CITY OF ALBUQUERQUE

October 9, 2024

**RE: 6208 Whiteman Dr. NW
Grading and Drainage Plan
Engineer's Stamp Date: 9/30/24
Hydrology File: E10D127**

ENGINEER'S SEAL	LOT11 BLK5 U3 VC SUB. 6208 WHITEMAN DRIVE	DRAWN BY DEM
DAVID SOULE REGISTERED PROFESSIONAL ENGINEER 14522	GRADING AND DRAINAGE PLAN	DATE 4-1-24
9/30/24	Rio Grande Engineering	6208 Whiteman Dr. dwg
DAVID SOULE P.E. #14522		SHEET # C1
		JOB #

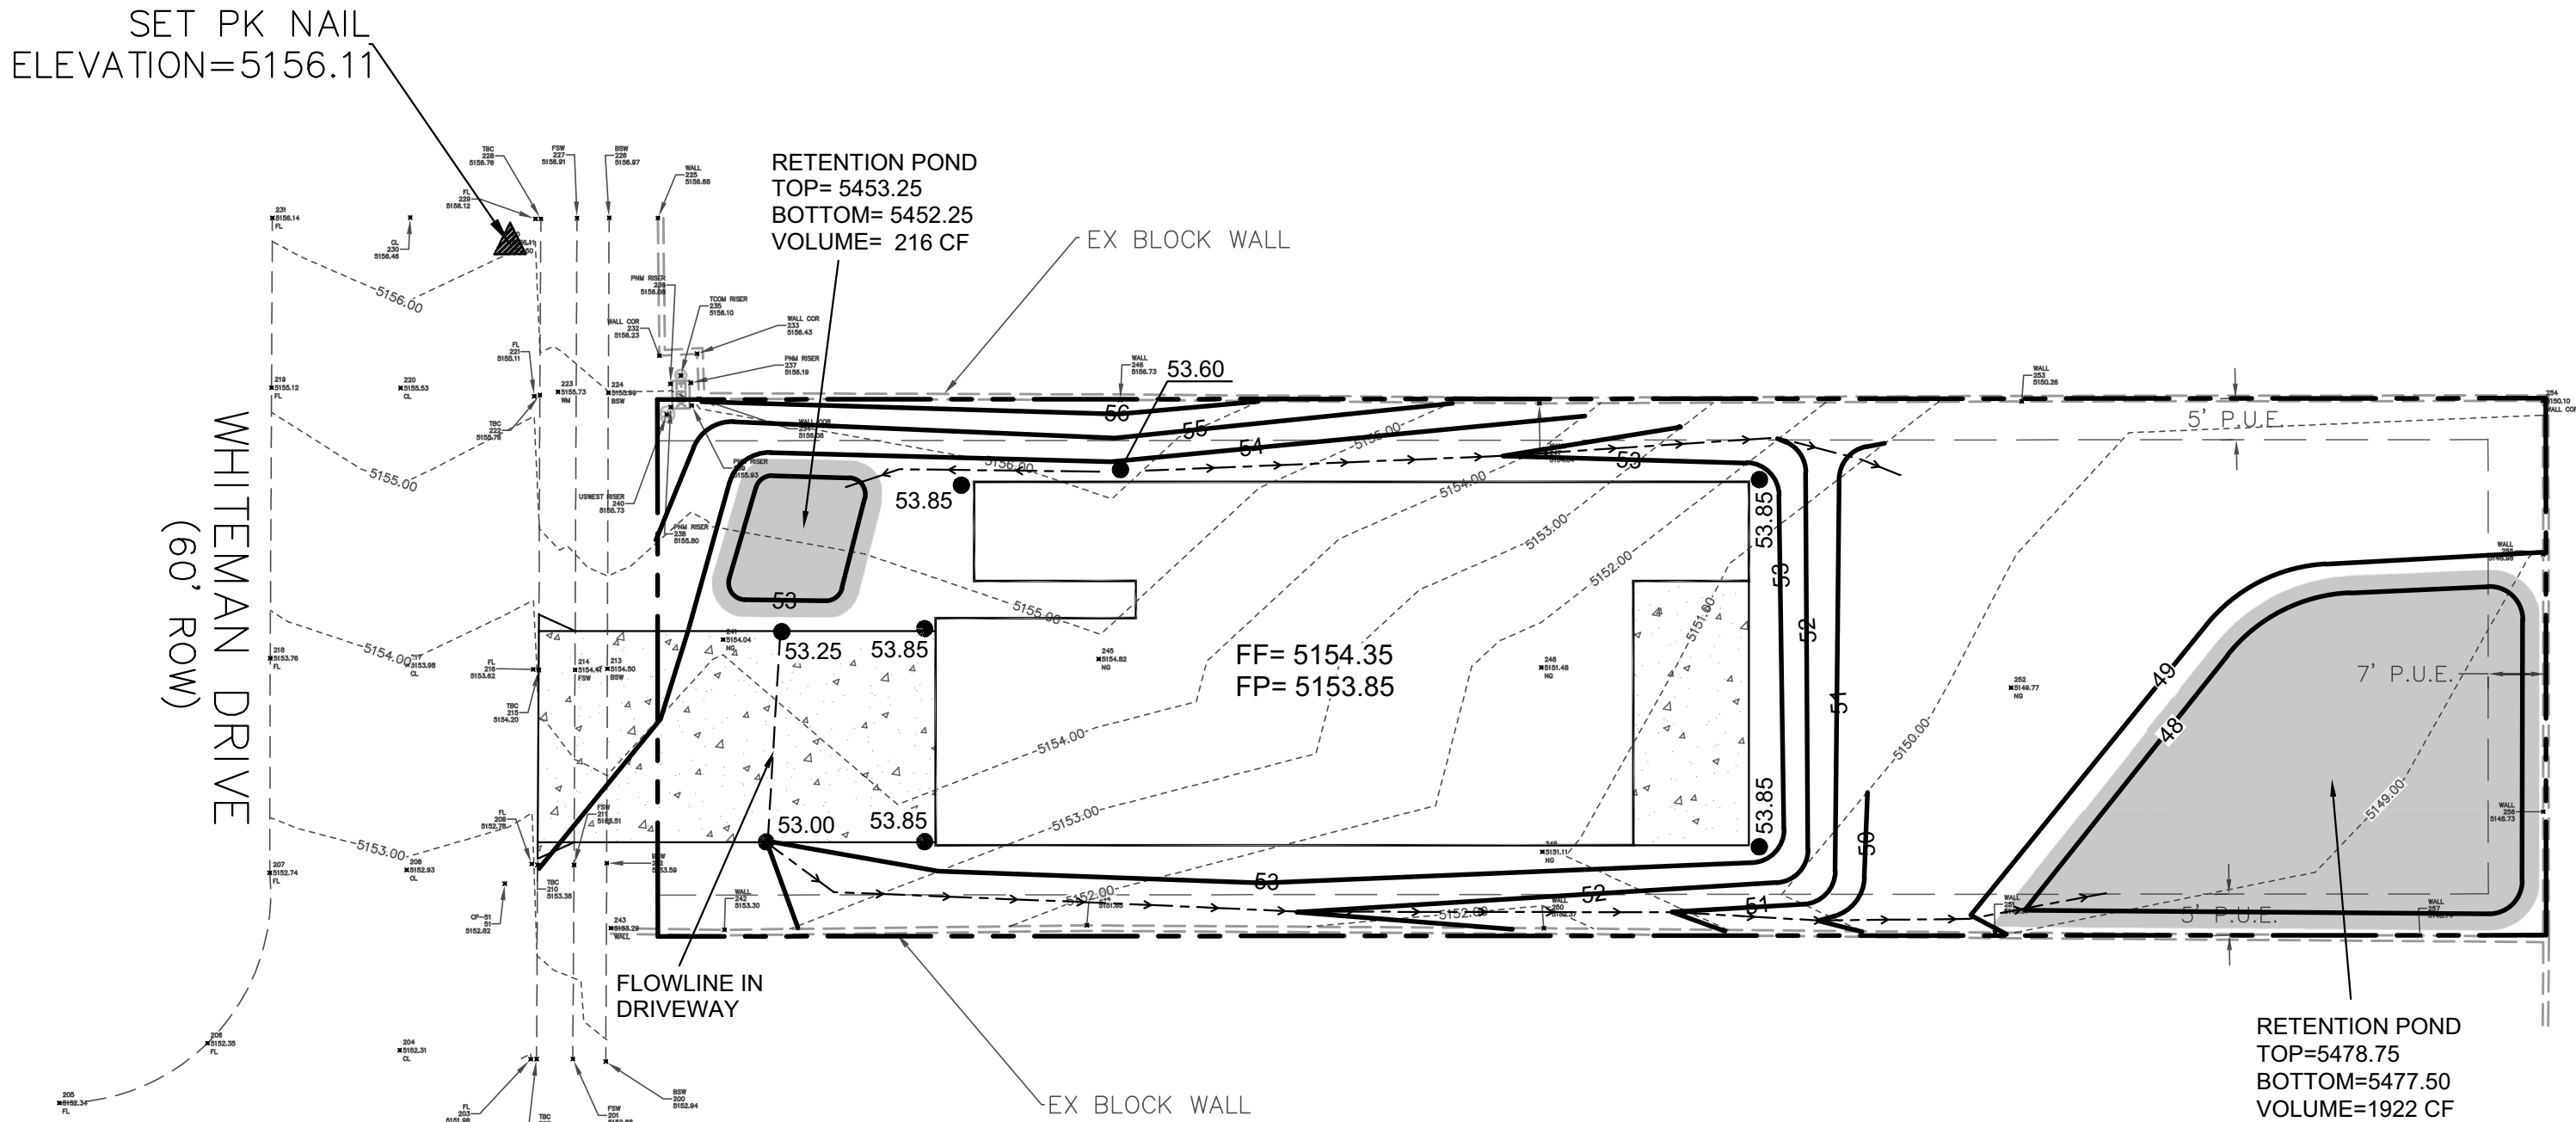
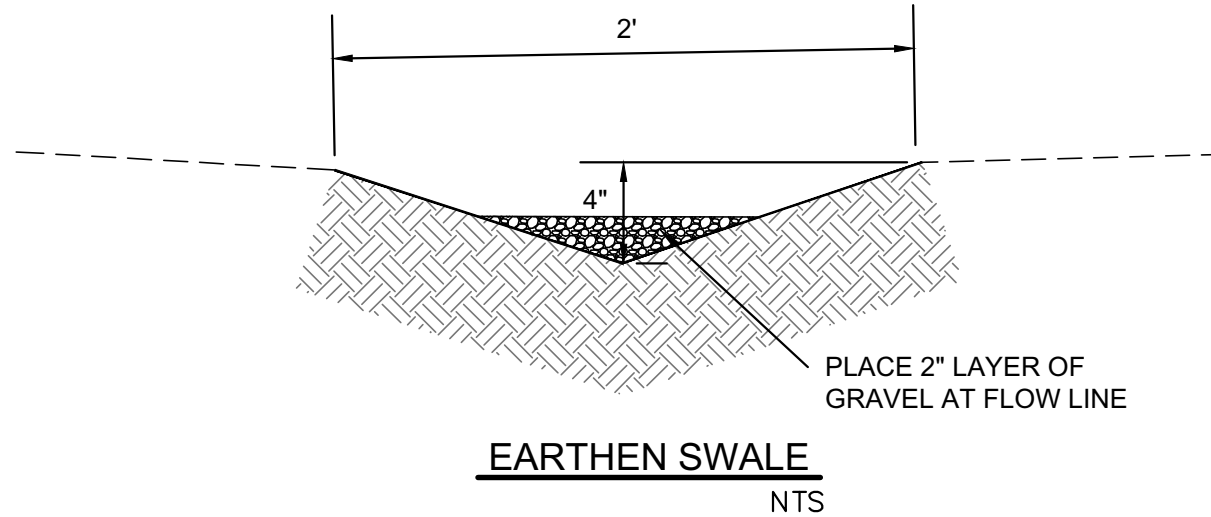
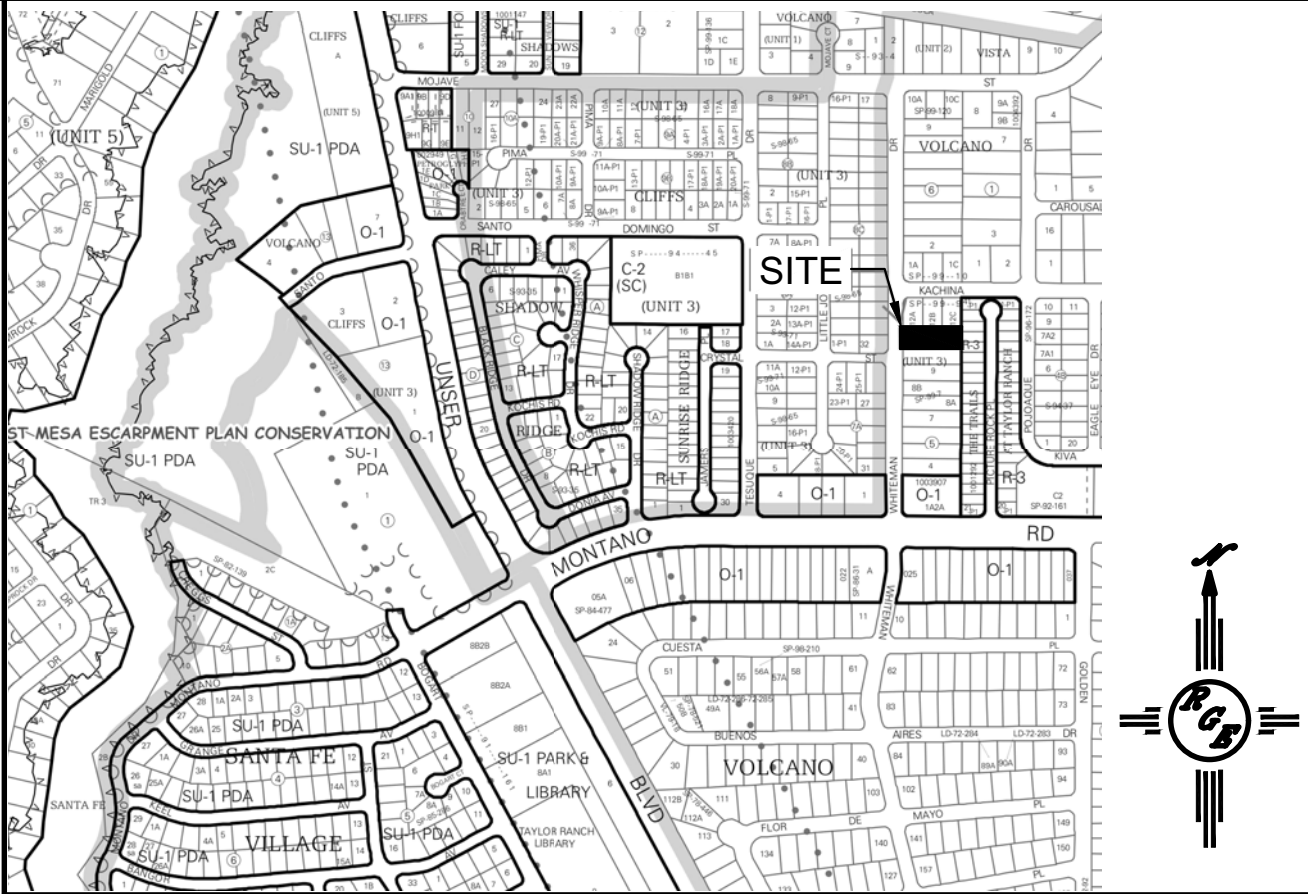
Based upon the information provided in your submittal received 10/01/2024, the Grading & Drainage Plan is approved for Building Permit and Grading Permit. **Since this site appears to be relatively flat and grades slightly to the rear, a pad certification is not needed for this project.** Please attach a copy of this approved plan in the construction sets for Building Permit processing along with a copy of this letter.

1. Engineer's Certification, per the DPM Part 6-14 (F): *Engineer's Certification Checklist For Non-Subdivision* is required.
